# intel® Technical Advisory

TA-0288-1

## C440GX+, SKA4 Systems and AKORETENTION, Pentium® III XEON™ Dual Processor Retention Modules May Have Defective PEM Nut Clips

Figure 1. Dual Retention Module

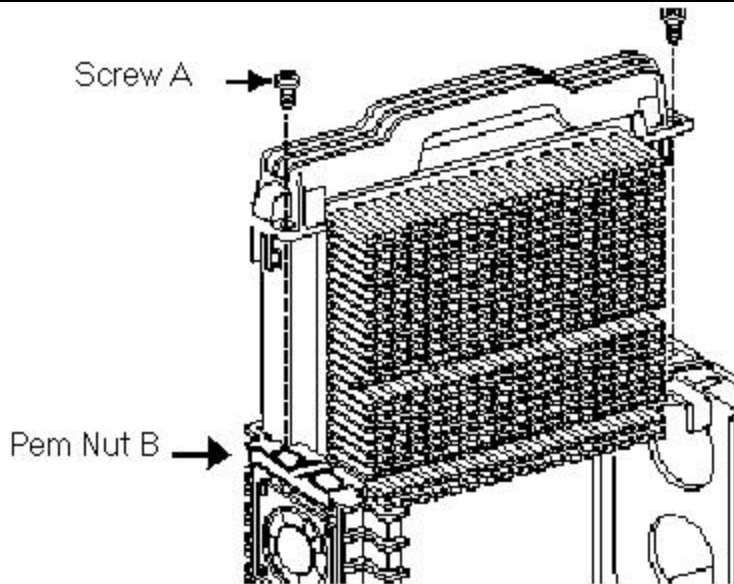
A few Dual Retention Module (DRM) kit bracket 6X32 ½ screws (A) will not fully turn into the bracket clip with PEM nuts (B) on the retaining bracket as shown in Figure 1 on page 2. Depending upon the torque used, the 6x32 screws may install about two thirds of their length before binding (cross threaded) in the clip's metric PEM nuts. This can be easily determined by attempting to turn the captive washers located under the head of the screws. If the captive washers under the screw heads turn easily with your fingers, the screws are not fully seated. An easy way to test if the PEM nuts are metric is to thread the screws in by hand. They should install very easily for their complete length if correct 6X32 PEM nuts are present. The screws will bind very quickly, at less than 2/3 of their length, if the metric PEM nuts are encountered.

Metric PEM nuts were mixed with the SAE 6X32 threaded PEM nuts. All of the PEM nuts should be threaded for 6X32 screws. In the C440GX+ boxed board product, the DRM kit (plastic bag of parts) is labeled with part number 711906-001. This kit contains two each base assemblies (with the PEM nut clips), eight each 6X32 X 1/2 screws, and two CPU headers in a sealed plastic bag.

The user should check all boxed boards for DRM kits with dates between April 12<sup>th</sup>, 2000 and June 21<sup>st</sup>, 2000 to insure the correct (6X32 threaded) PEM nuts were installed. If you find a defective DRM kit with the incorrect metric PEM nut clips, it may be replaced through the standard warranty replacement procedures. A new DRM kit may be ordered with Product Code AKORETENTION (MM# 821617). The new DRM kit will have an Intel part number 711906-003 or 711906-004. The -003 kit has reworked base assemblies and the -004 kit has new injection molded plastic parts. Both kits will have the correct 6X32 PEM nuts included.

Note: The new replacement DRM (AKORETENTION) kit part number is 711906-003 or -004. An original DRM kit with part number 711906-001 dated before April 12, 2000, will have the correct 6X32 PEM Nuts installed but will not have the reworked base assemblies. The -003 and -004 kits base retention modules have an additional .030" of clearance added for the processor cartridge.
